KCAA/CONF/1010/3/VOL.61 (188)

ADDENDUM AND THE FIRST AND FINAL CLARIFICATIONS OF THE TENDER FOR THE SUPPLY, DELIVERY, INSTALLATION, TRAINING, TESTING AND COMMISSIONING OF AIRSPACE DESIGN AND PLANNING TOOL AND RELATED EQUIPMENT (AUTOMATIC FIRE SUPPRESSION SYSTEM FOR JKIA, MIA, EIA, WIA, POROR RADAR STATION)– LOT 1 AND 2; TENDER NUMBER KCAA/032/2025-2026.

RESPONSE TO FIRST CLARIFICATIONS SOUGHT BY INTERESTED BIDDERS VIA EMAIL AND DURING A MANDATORY PRE-BID MEETING FOR SUPPLY, DELIVERY, INSTALLATION, TRAINING, TESTING AND COMMISSIONING OF AIRSPACE DESIGN AND PLANNING TOOL AND RELATED EQUIPMENT. (RE-TENDERING): TENDER NUMBER KCAA/032/2025-2026:

ANNEX 1: (ADDENDUM)

Annex 1 Ergonomics

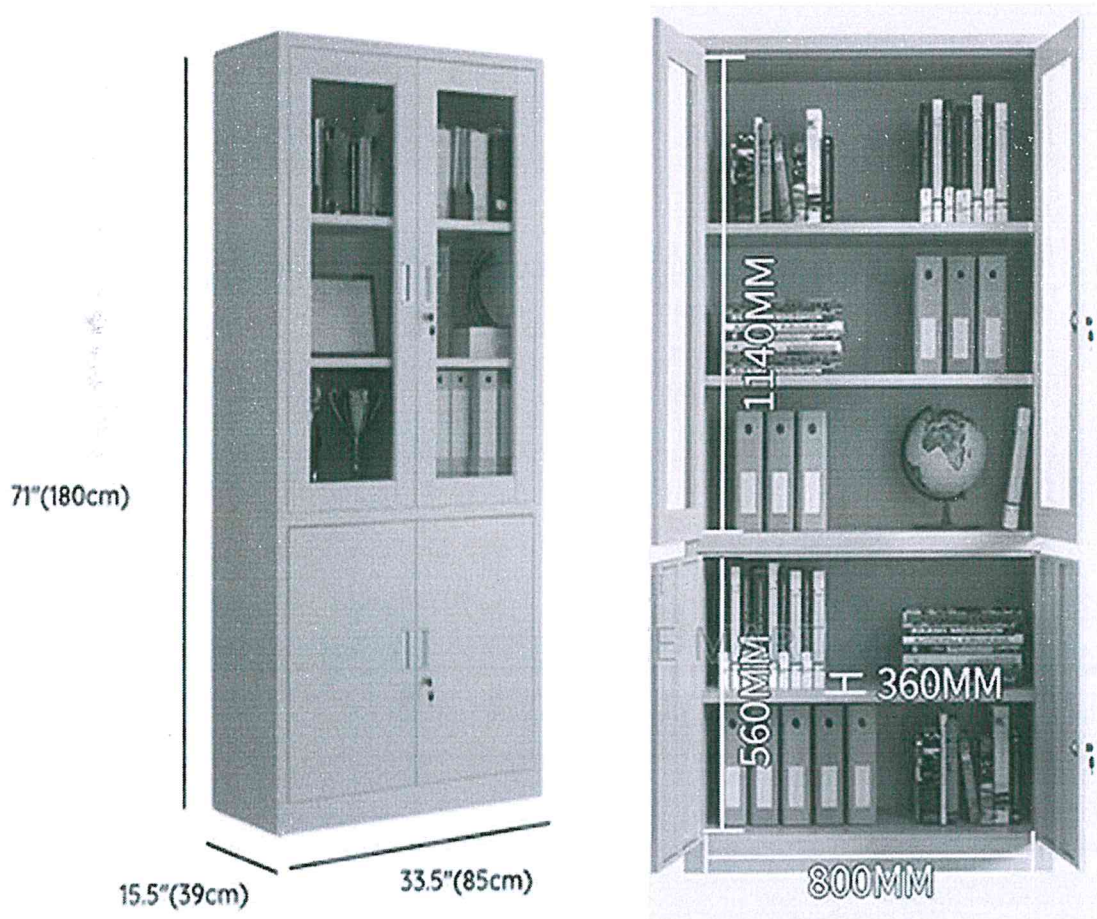
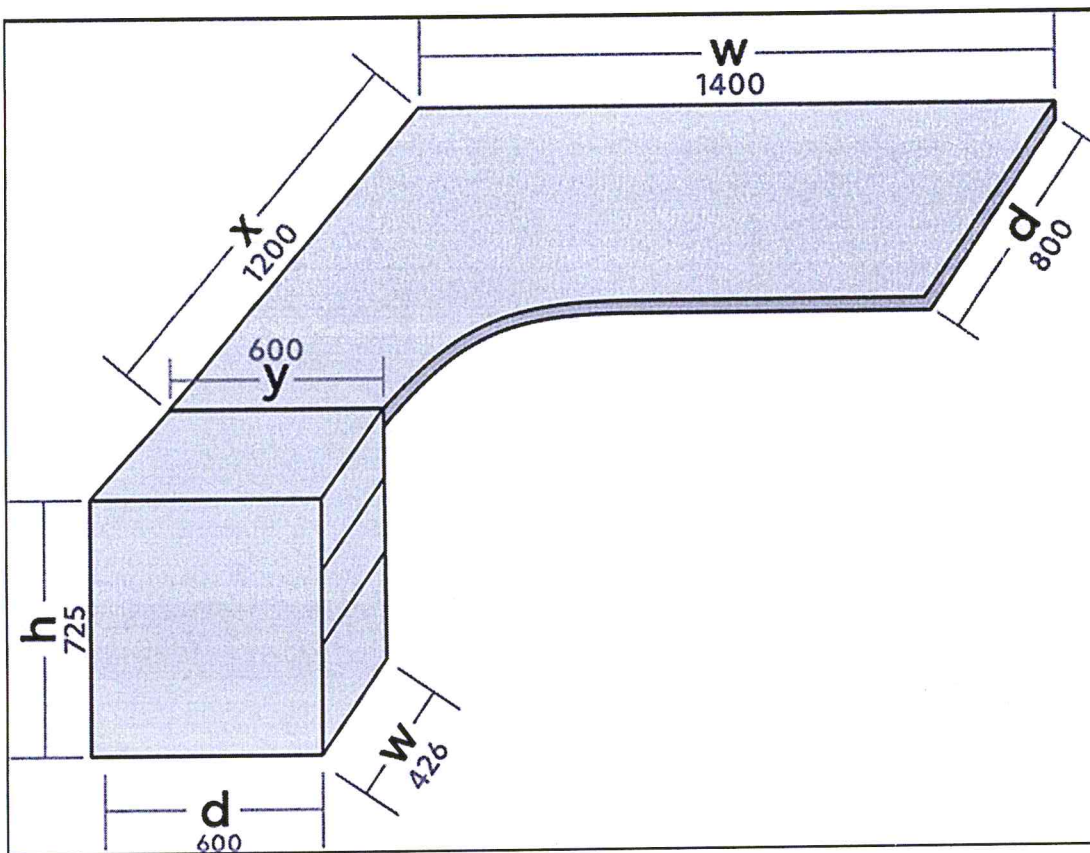
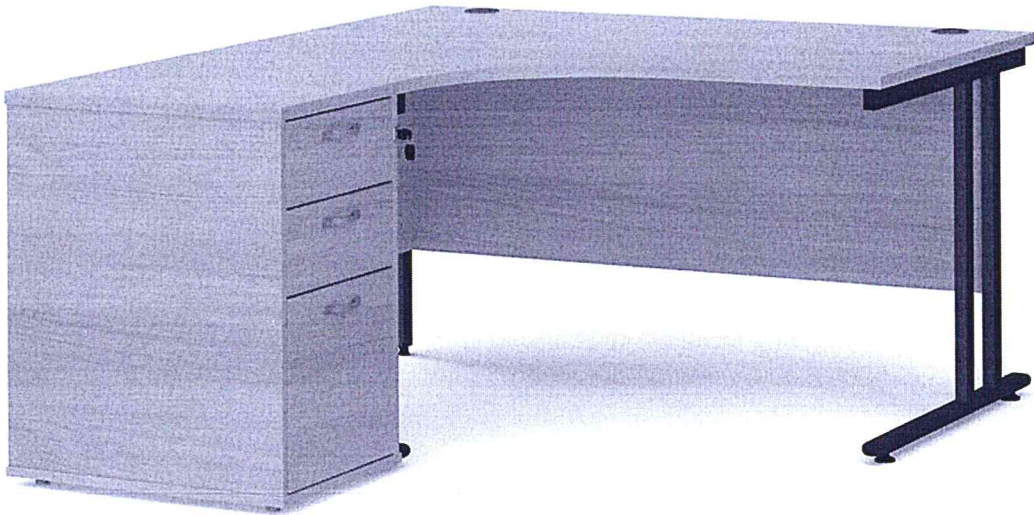
5.	What about the specs for chair and tables? Page 96.	The addendum herein attached includes the technical specifications for the ergonomics.
6.	Clarify on the preliminary requirement No. 29.	The requirement should read as follows:

Suitable chairs and tables shall be supplied for every working position (apart from the technical position).

The supplier in liaison with KCAA project implementation team shall setup the working environment as deemed comfortable by both parties. Proper cable management shall be done by the supplier. Details of the furniture are attached in Annex 1 herein attached.
